飛宏企業股份有限公司
PIIHONG ENTERPRISE CO., LTD.

SCHEMATIC

MODEL	PSM-4012-2/28	
DRAWN	AMY CHEN	78.7.7
DESIGN	78.7.7	
CHECKED	Summer Lin 7/14/90	
APPROVED	H.L.H.	
DRAWING NO.	PES-30274	REV.
		F

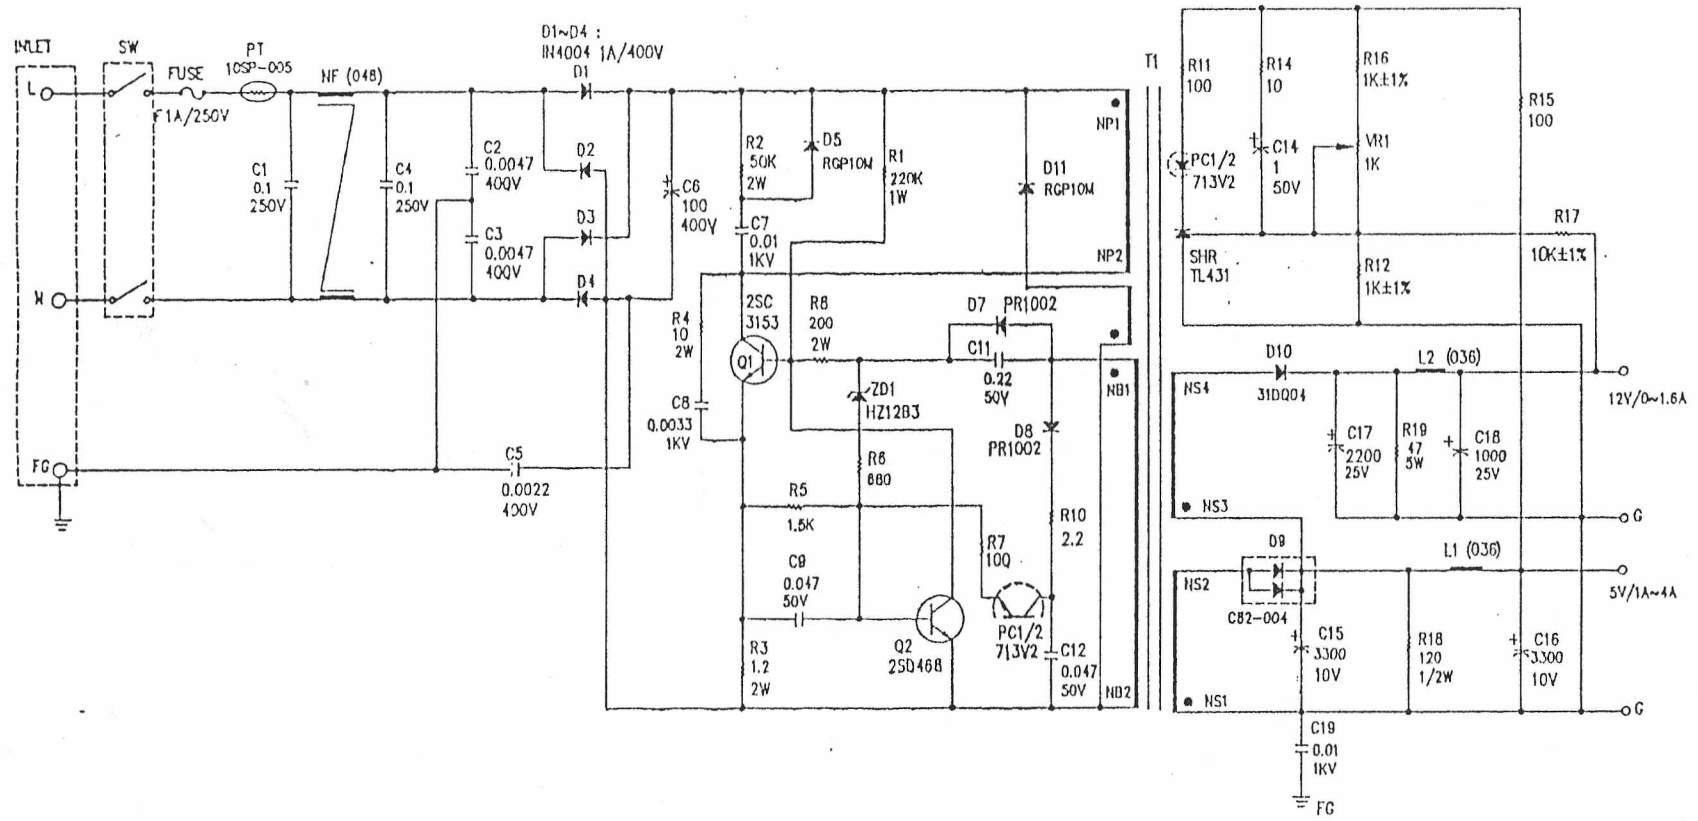
CHECK & ISSUES	DATE
A. C3, HF WAS (050) OF 6, C9 WAS 0.047	77.12.14
OF 6, R6 WAS 680, ZD1 WAS HZ11B1	
OF 9, C15 WAS 4700UF, C10, C16 WAS 2200UF	
OF 2, FUSE WAS F2A OF 5, C8 AND R4 CONCEL	
OF 10, C17 AND C18 WAS 16V	78.1.4
B. 005 ADD R4, C8 OF 6 ZD1 WAS HZ-12B3	
OF 6 R1 WAS 270K 1/2W	
OF 6 R6 WAS 680 OHM OF 5 C9 WAS 0.001UF	
OF 31 INPUT: WAS 250VAC	
C. OF 6 ZD1 WAS HZ-11B1	78.1.21
D. OF 2 PT WAS SPOOS OF 8 SHP WAS UL/43	78.3.1
E. OF 7 C12 WAS 0.01 50V	78.7.7
F. OF 10 R17 WAS 15K 3/4W	77.5.21
